g.b. Addl  
Steel Twin Screw Steamer "ABHONA".

Dimensions ; 390' x 49'-11 $\frac{1}{2}$ " x 24'-6" Moulded Upper Deck

Copy of midship section finally approved on the 30th December last.

A diagrammatic profile sketch of the vessel is given below.

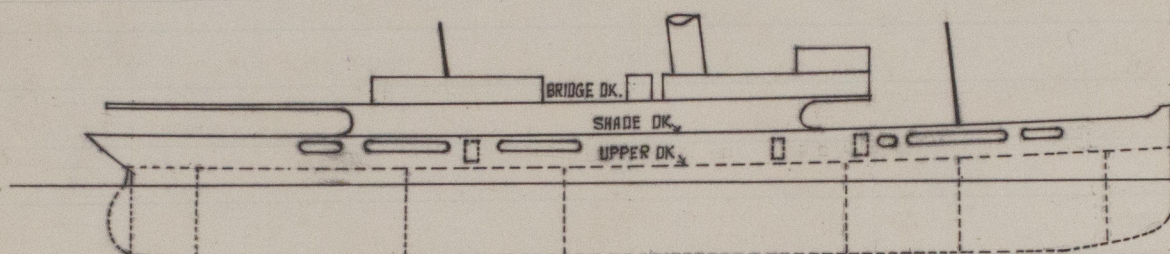
The structural arrangements in this vessel are satisfactory; indeed in some respects - for example, in respect of the number of decks and of the relatively moderate sheer - they are such as to contribute materially to her structural efficiency.

As will be seen from the profile sketch of the vessel, attached hereto, she had a considerable extent of superstructure above the upper deck, the sides of which were open in places to facilitate ventilation of the spaces where coolie passengers were to be carried. These high superstructures necessarily tend to raise the centre of gravity of a vessel, and when the sides are open in places as in this instance the vessel has not so large a range of stability as is the case with high sided vessels in which the side plating is intact.

While calling attention to these points it is yet considered that in the absence of detailed particulars of the manner of loading there does not appear to be any prima facie reason for supposing there was any deficiency of stability in the vessel.
